Service Bulletin

REFRIGERATORS
20' AND 22' BOTTOM FREEZERS

REF 01-08

ICE CLUMPED IN ICE BUCKET AND ON FREEZER FLOOR

Figure 1-Locking tab on fill cup

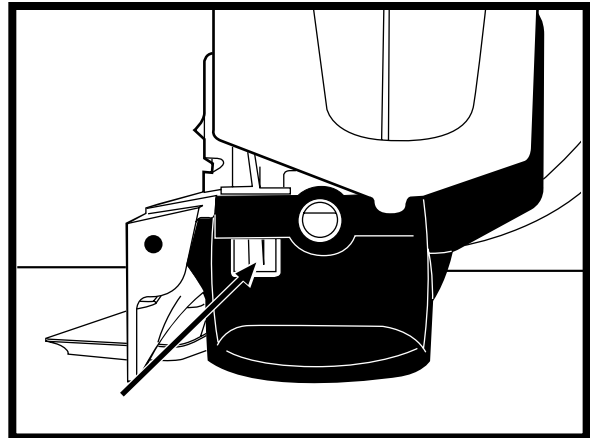
1. Remove the fill cup, mounted to the rear of the ice maker, by depressing the locking tab at the rear of the icemaker mold body, lifting the fill cup up, away from the icemaker.

Figure 3-Fill cup with extension installed

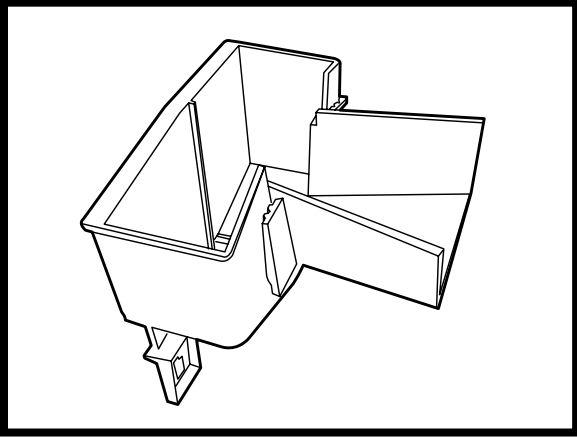
2. Attach the fill cup extension (service part number **WR29X10078**) to the fill cup by sliding the extension onto the rear of the fill cup. Ensure the extension is pushed fully into the slot on the fill cup as shown in Figure 1.

Fig 1

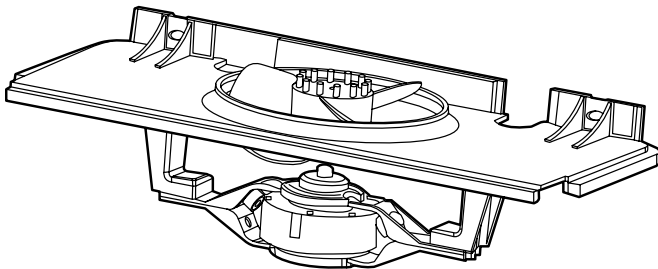
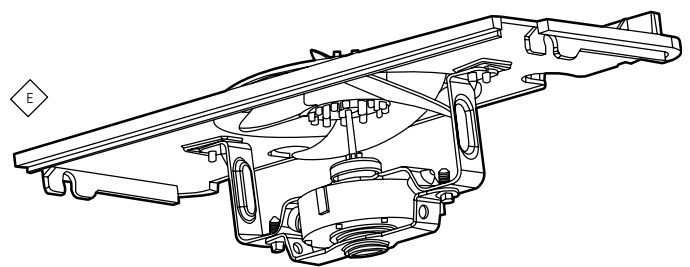
You may find an ORIFICE FAN ASSEMBLY (Fig. 1) instead of the Orifice Fan referenced in IPC (Fig. 2), this change is made to address a noise issue.

Install "ORIFICE FAN ASSEMBLY KIT", **WR49X10190**. This will alleviate the evaporator fan noise.

MONOGRAM® SABBATH KIT

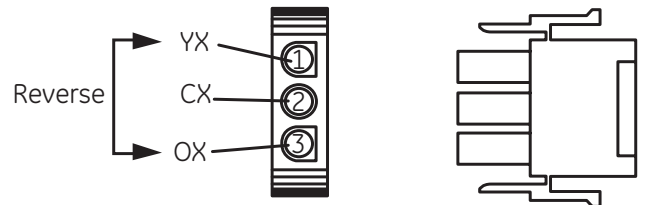
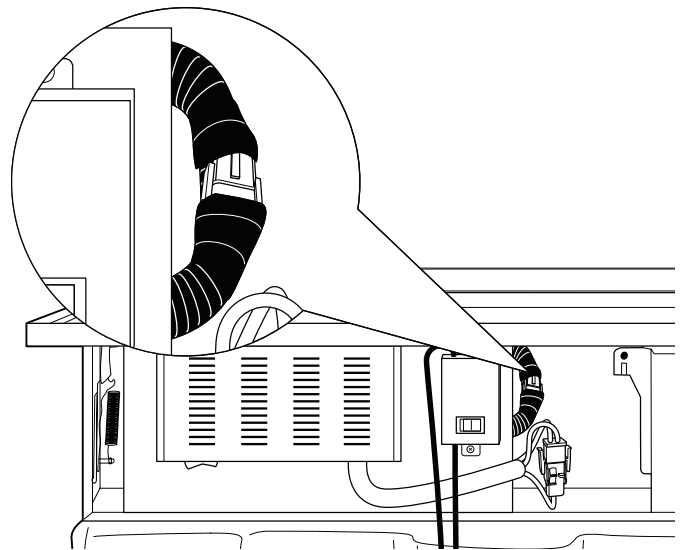
2008 Monogram side-by-side refrigerators may have reversed wires on the AC harness connections to the Sabbath Kit. The reversed wires will cause a tripped circuit breaker or blown house fuse when the Sabbath switch is turned on. Turning off the Sabbath switch will allow the refrigerator to function until the incorrect wiring can be repaired. The harness connections can be repaired by moving 3 pins in the connectors.

- Locate the Sabbath Connectors on the AC harness behind the water filter.
- Remove the tape and disconnect the connector.
- Reverse the yellow wire and the orange wire in the male connector. The connector pin diameter is 0.084. A pin extractor tool such as the AMP 1-804030-1 can be used.
- Move the yellow wire in the female connector to the empty pin location.

PBA Main Best

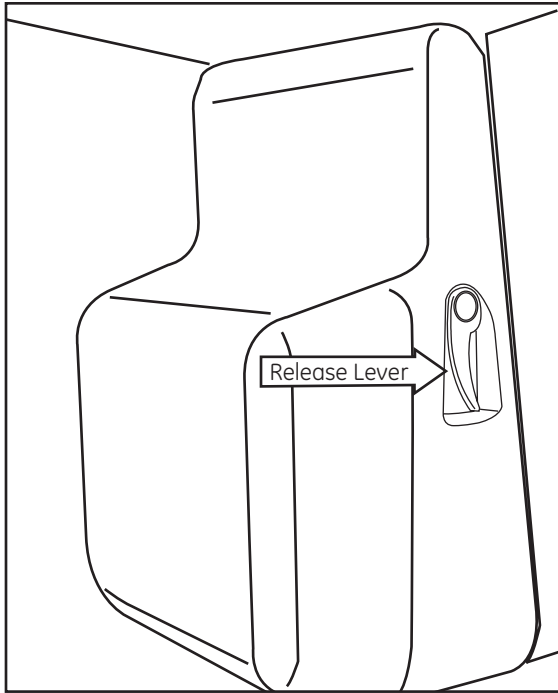
When the icemaker dumps ice cubes to the ice bucket, ice cubes jam between the icemaker and the liner. The icemaker makes a loud noise and eventually stops working.

Replace icemaker kit and main PCB. Parts code remains unchanged.

Replace main board if software version is lower than 4.02 on left processor.
